**Pacific Gas and
Electric Company®**

PG&E Letter DCL-10-082

Response to NRC Letter dated July 6, 2010, Request for Additional Information for
the Applicant's Environmental Report - Operating License Renewal Stage

**PG&E Response to NRC Letter dated July 6, 2010
Request for Additional Information for the Applicant's
Environmental Report – Operating License Renewal Stage**

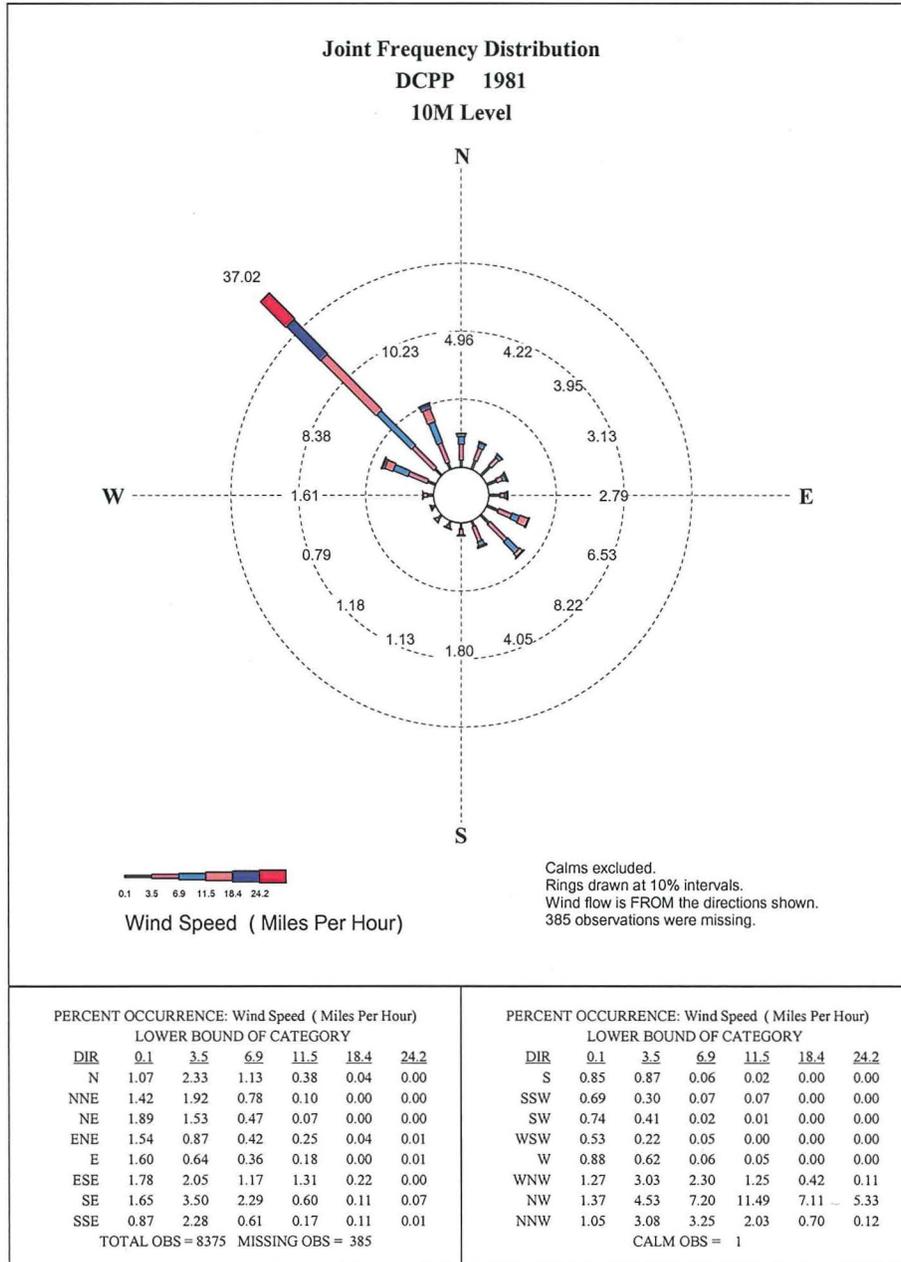
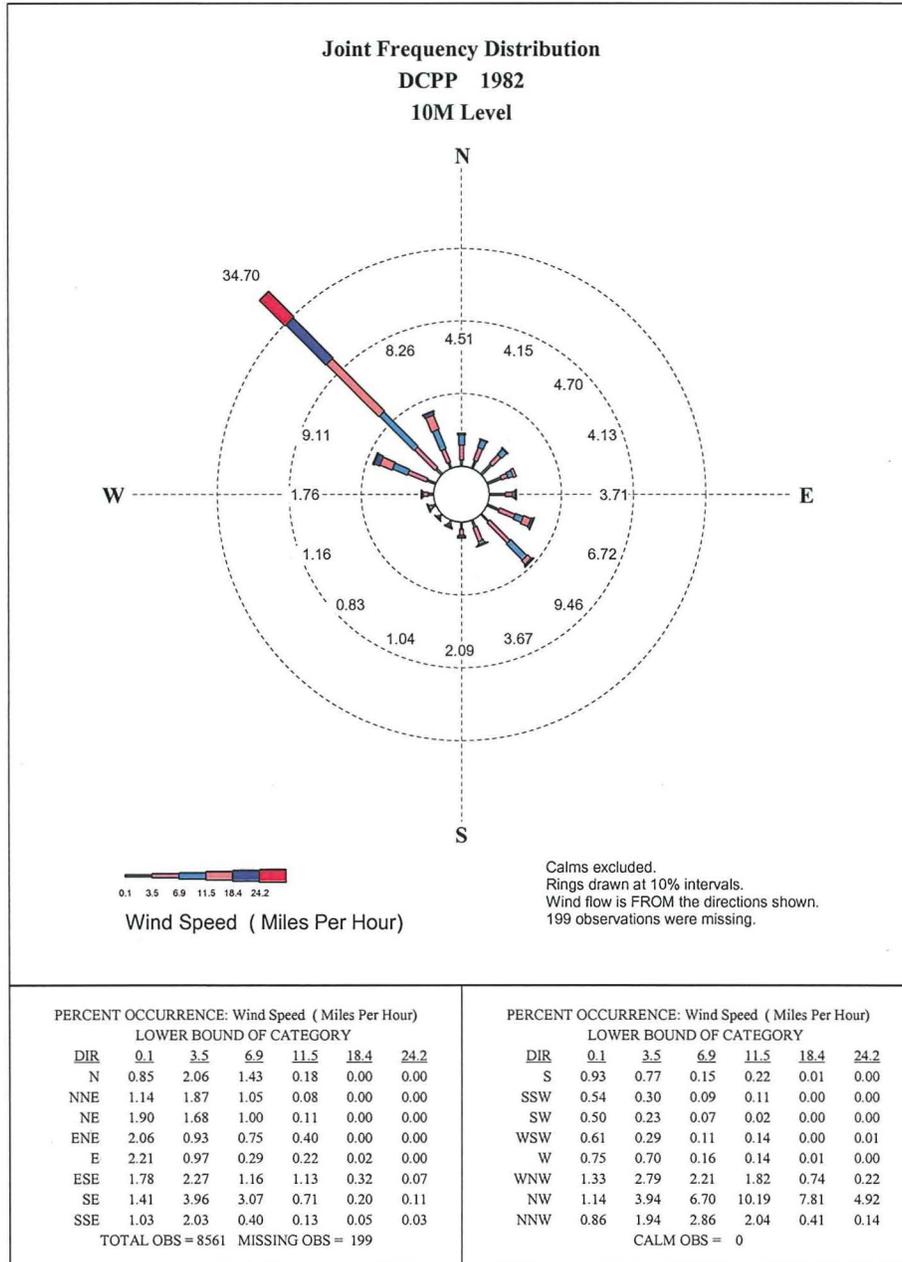
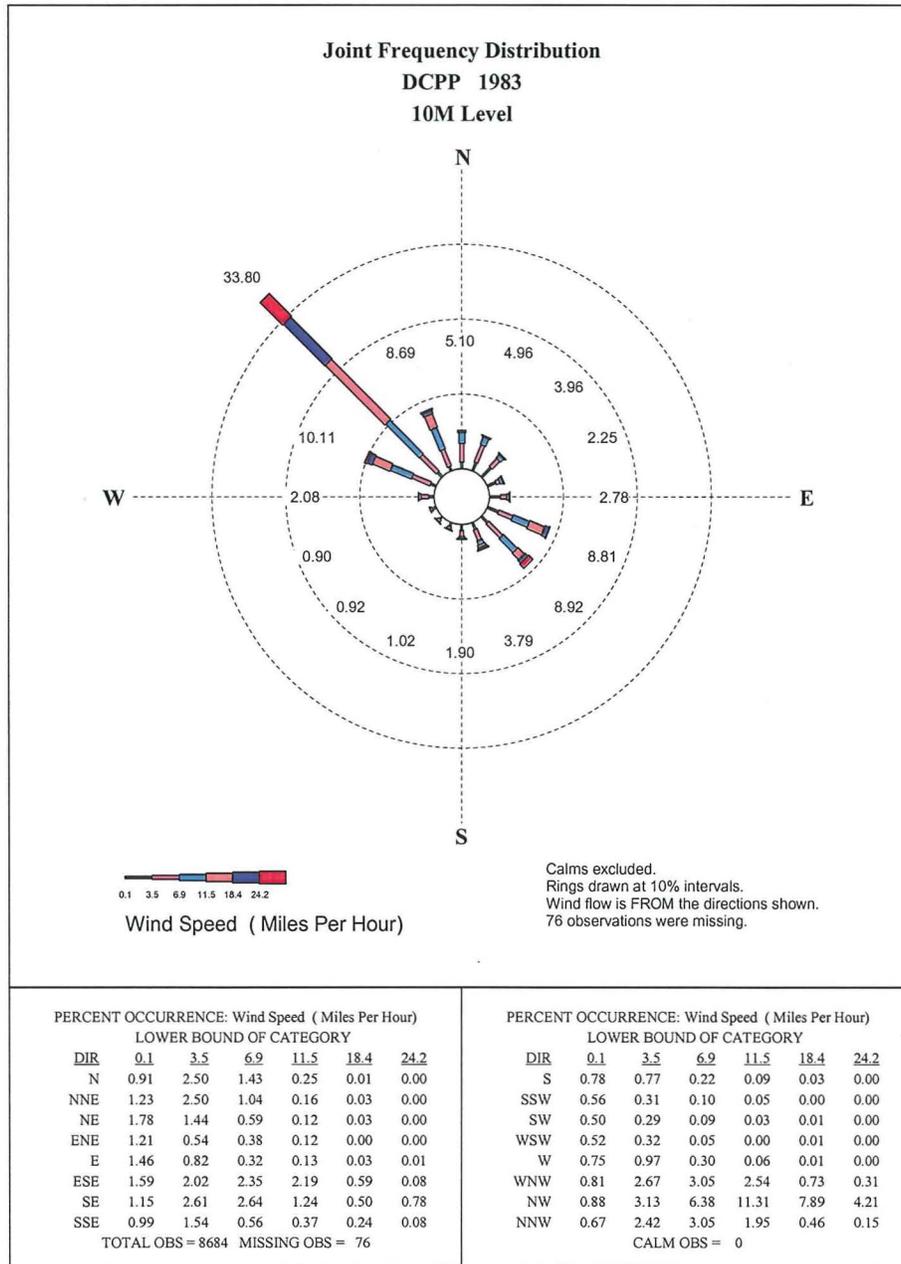
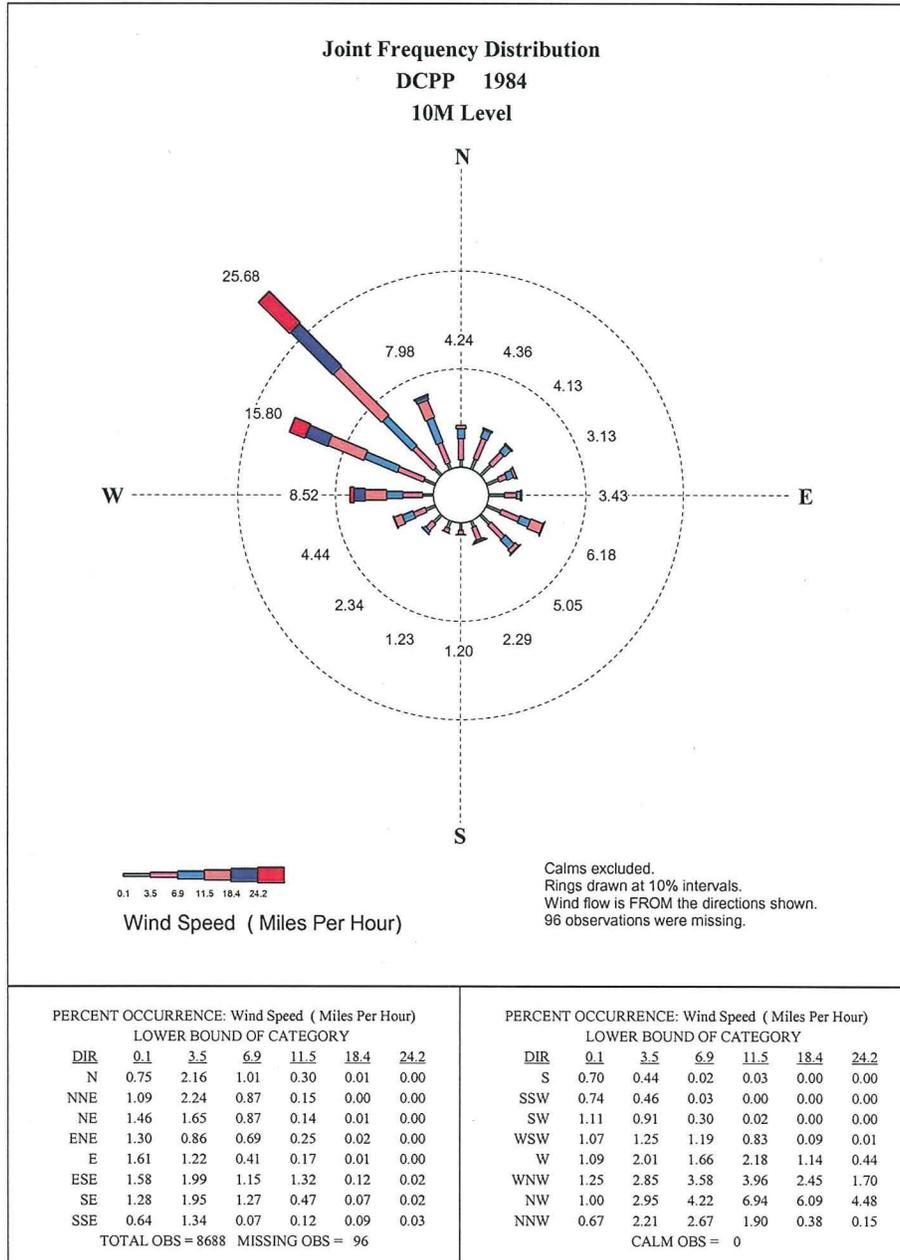
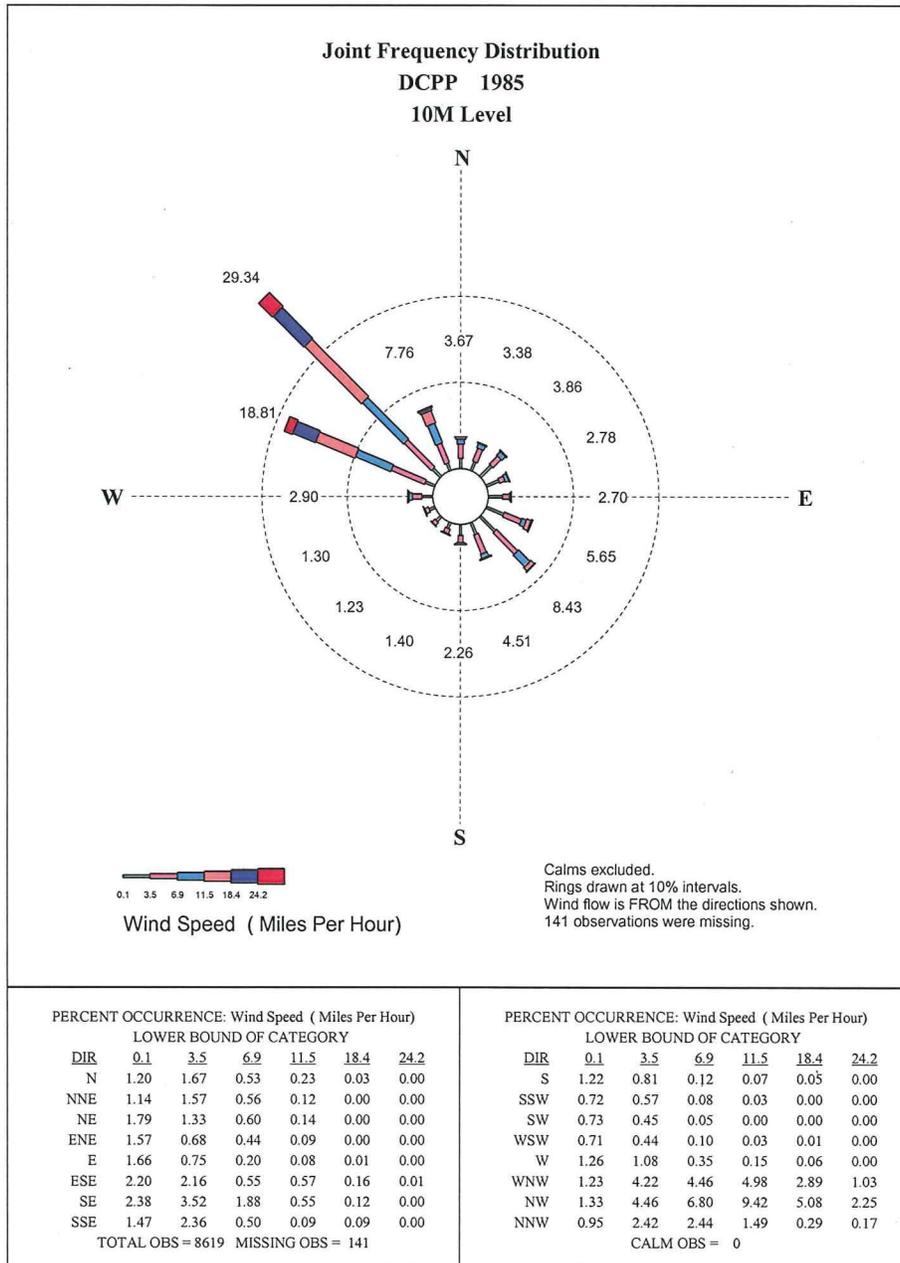
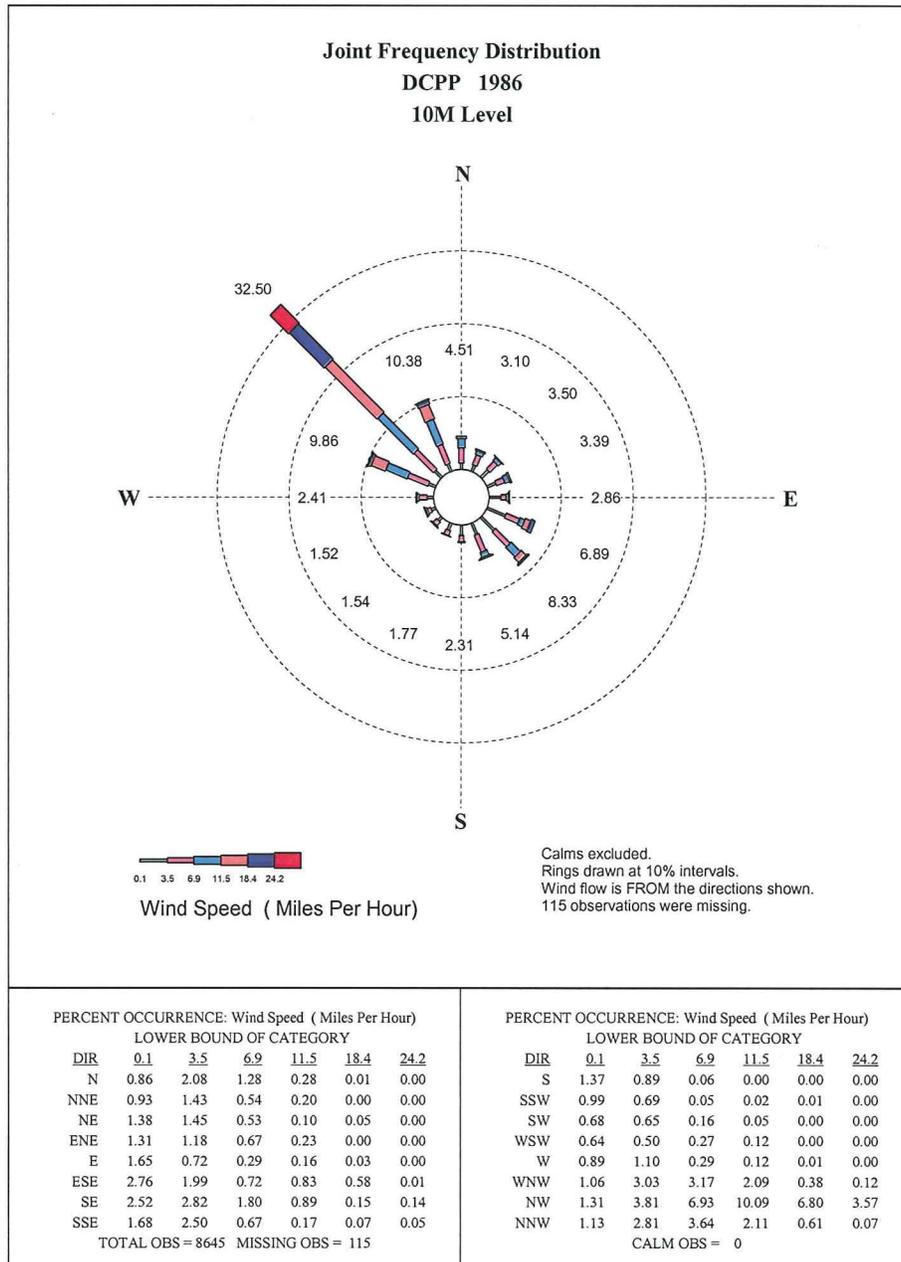
Regulatory Guide 1.23, Revision 1 states that “Whenever possible, wind measurements should be made at locations and heights that avoid airflow modifications by obstructions such as large structures, trees, and nearby terrain. The sensors should be located over level, open terrain at a distance of at least 10 times the height of any nearby obstruction if the height of the obstruction exceeds one-half the height of the wind measurement.” During the Diablo Canyon Site Audit, the NRC meteorology reviewer noted that the onsite meteorological tower is within 250 feet of the Simulator building. Given that the building height is about 35 feet – approximately the same elevation as the 10 meter wind speed sensor – its proximity to the meteorological tower could influence the wind speed and direction data used in the SAMA analysis. The meteorological tower is also located within an asphalt parking lot, which could potentially affect the stability classification under certain meteorological conditions (e.g., sunny days with low windspeed). Justify that the meteorological data used in the SAMA analysis (collected at 10 meters) are high quality data representative of the Diablo Canyon site and are not adversely affected by the siting of the meteorological tower.

The calendar year wind roses for the 10-meter level of the DCP primary meteorological tower are presented in Figures 2 through 14. As is evident in each wind rose, the prevailing wind direction at this site is northwest. Generally, the wind direction is from the west-northwest, northwest, and north-northwest between 50 and 60 percent of the year. On average, winds from the northwest occur 33.7 percent of the time. Wind directions from the east-northeast, east, and east-southeast occur, respectively, 3.0, 3.2, and 6.6 percent of the time.

A visual year-by-year review from 1974–1982, 1983, and 1984 when the simulator building was constructed, and 1985 and 1986 (post simulator building), indicates no significant change in the wind direction distributions. The only change evident in the wind roses is in 1984 and 1985 when there was an increase in west-northwest directions, which may be the result of more frequent Pacific storms during that two-year period.
